Final Technical Evaluation Report  
for DOE's Remedial Action at the  
**LAKEVIEW UMTRA**  
**PROJECT SITE**  
Oregon

November 1990

Uranium Recovery Field Office  
Region IV  
Nuclear Regulatory Commission

Figure 4

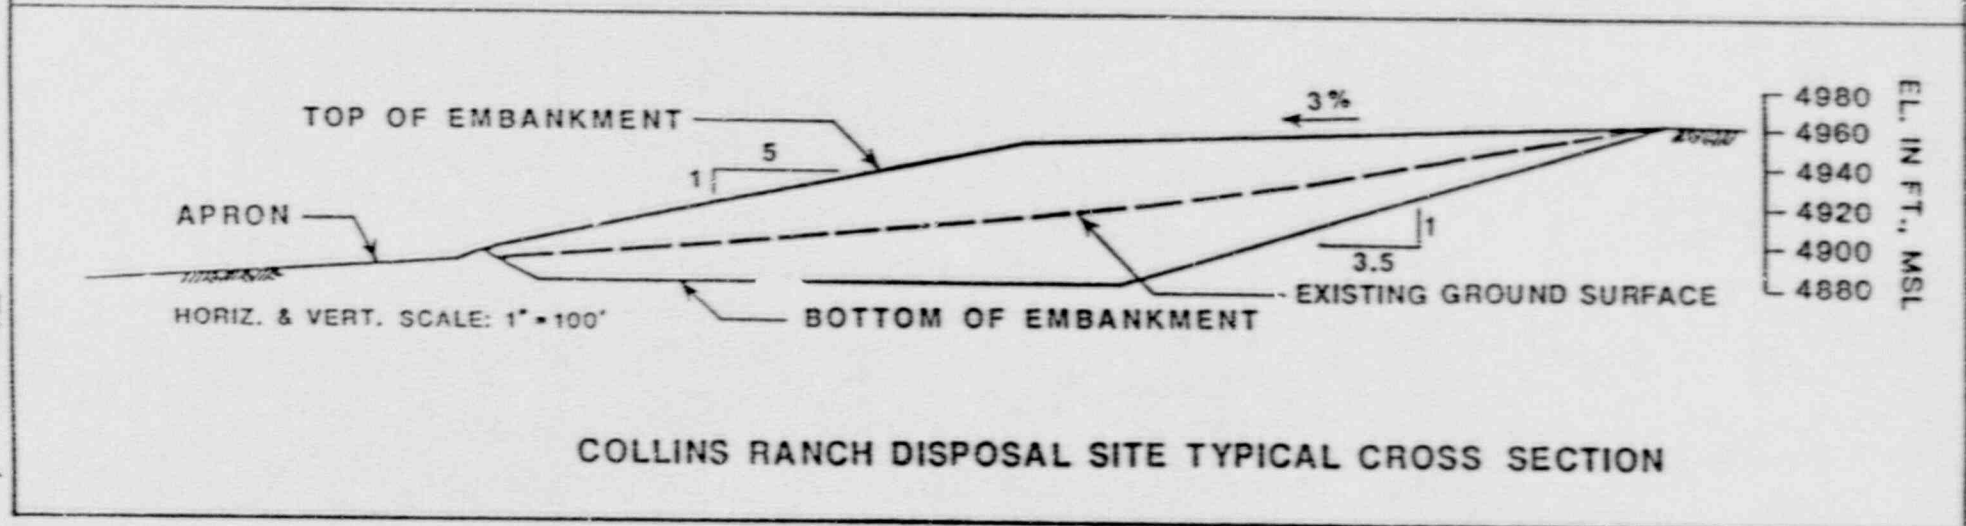
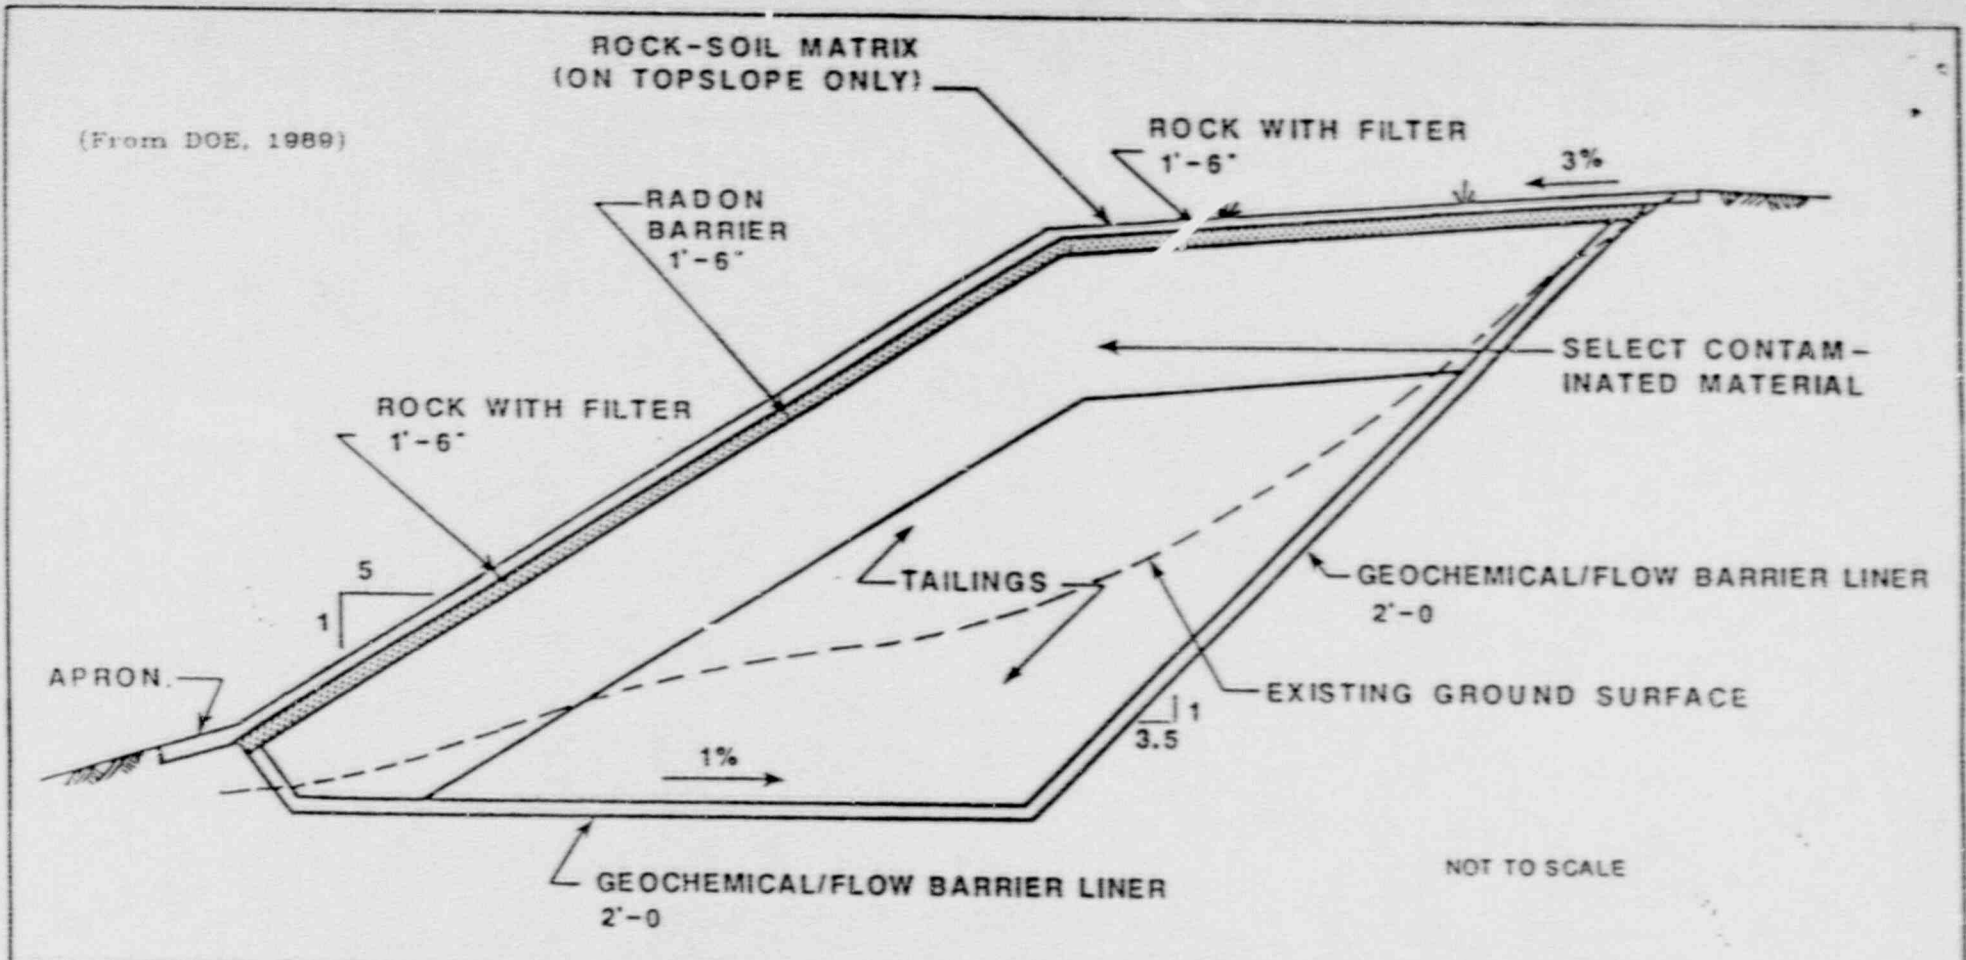
A typical cross section of the reclaimed pile is shown on Figure 4. The cross section consists of the following layers: rock erosion protection, radon barrier, contaminated materials, tailings, geochemical/flow barrier liner, recompacted foundation soils, and natural foundation soils. The top of the pile will be graded to a slope of approximately 3 percent, while the embankment outslope will consist of 20 percent slopes.

The tailings will be consolidated into a single pile, which will be protected by a soil and rock cover. As shown in Figure 4, the cover will have maximum slopes of approximately 3 percent on the top and 20 percent on the sides. Disposal will be partially below grade, and diversion channels will be located on the north and west sides of the pile as shown on Figure 5. A 20-foot wide apron will be constructed at the downstream toe of the embankment, where it meets existing ground.
